SHUGART SA400 MINIFLOPPY MAINTENANCE INFORMATION

## SA400 MINIFLOPPY

### ADDITIONS/CORRECTIONS TO SERVICE BULLETIN NO. 78

FIGURE 1 TEST POINT LOCATIONS

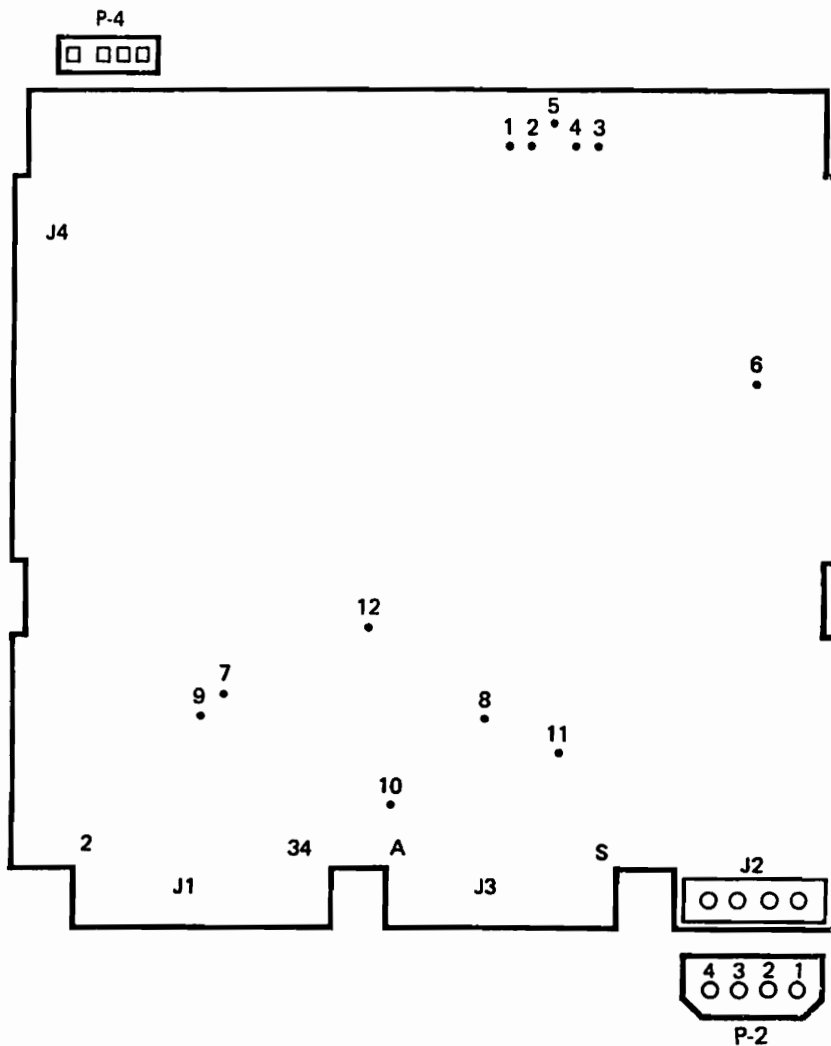
A design improvement was incorporated in all PCBs with a revision level of 2 and above. The revision level is located in the small block to the right of the board number (25060). This improvement changed R35 from 100 ohms, 1/4W to 39 ohms, 1/2W. For this reason, the Index/Sector Timing Adjustment (Section 3.4.8) MUST be performed when a PCB revision 0 or 1 is replaced by a revision 2 PCB or vice versa. When two boards of the same revision are interchanged, the index/sector timing should not change sufficiently enough to warrant readjustment. To eliminate any possibility of intermittent or compatibility errors, the index/sector adjustment should be set as close to 200 usec as possible.

FIGURE 1

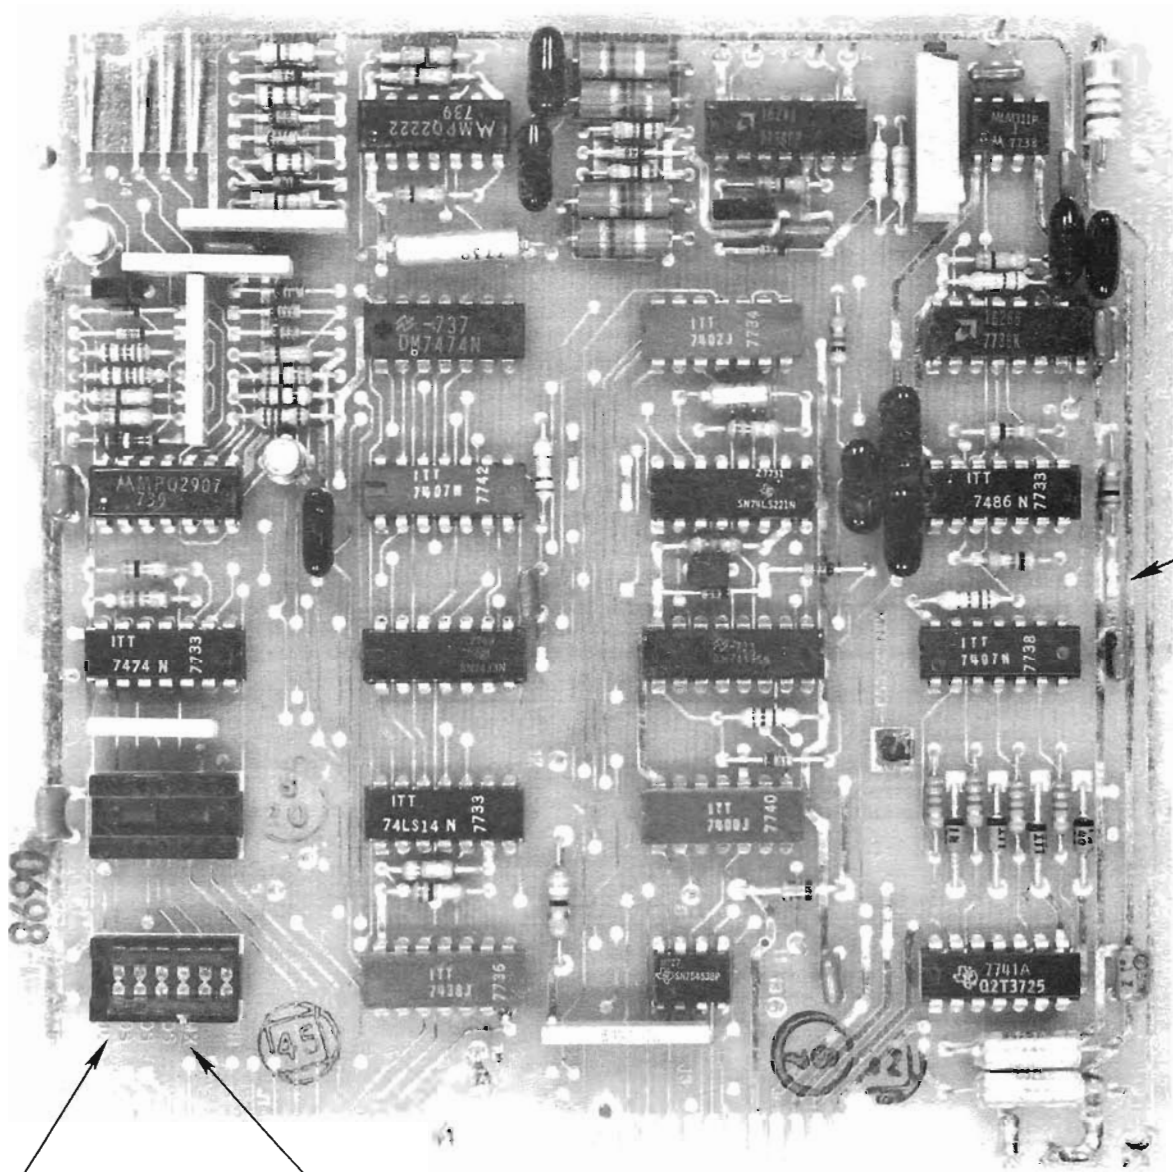
When floppy drives are purchased from Schugart Associates, some  
are checked and modified to include Wang required options and are then  
put into stock as 278-4004. The remainder are placed into stock under  
P/N 725-0057 unchecked and unmodified. Before installing the latter,  
the following modifications must be performed. See Figure 1.

- 1) Open location WP
- 2) Place six position shunt block such that HL does not have  
the capability of being jumpered (HL should be 7th position)
- 3 Lift the appropriate shunt pin so MX is not jumpered.
